1 ADDENDUM 1: DATE: 10-16-07

MD 396 (MASSACHUSETTS AVE) AND LITTLE FALLS PARKWAY

TRAFFIC SIGNAL PLAN

TS NO. 4600 | DRAWING NO. 1 OF 3 | SHEET NO. 19 OF 42

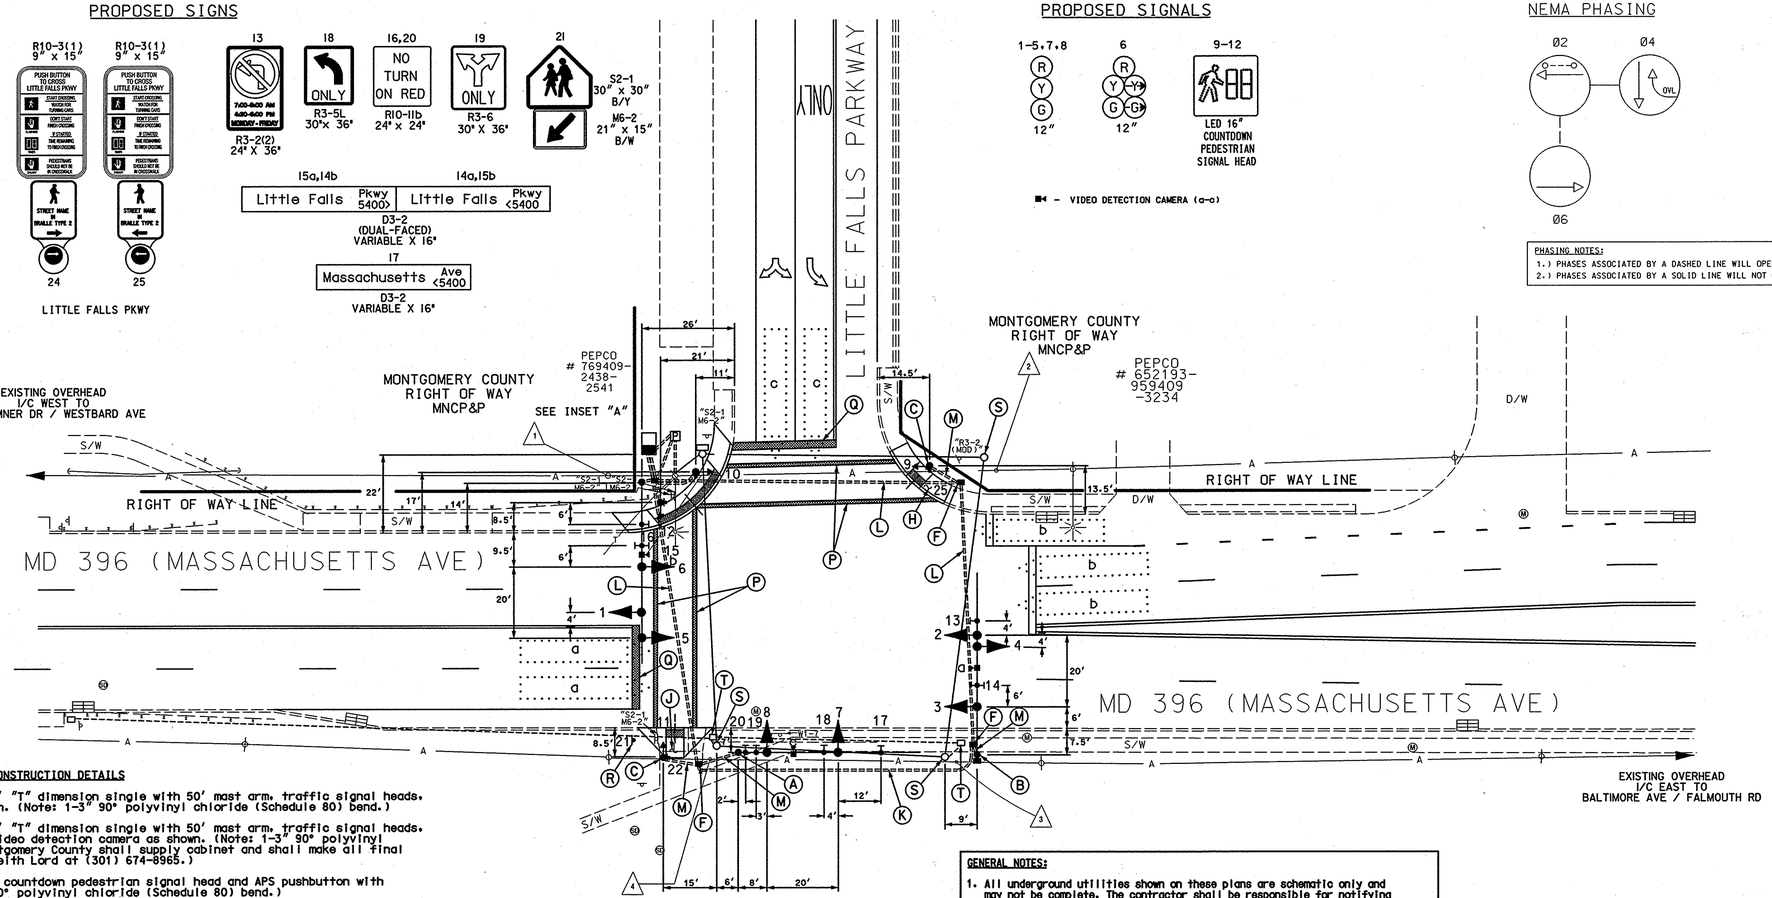
1 O. Install 3" polyvinyl chloride electrical conduit (Schedule 80) (trenched) with 50' of ~~3 wire~~ 1 conductor (No. 250 KCMIL) for proposed underground electrical power service by PEPCO to base of utility pole.
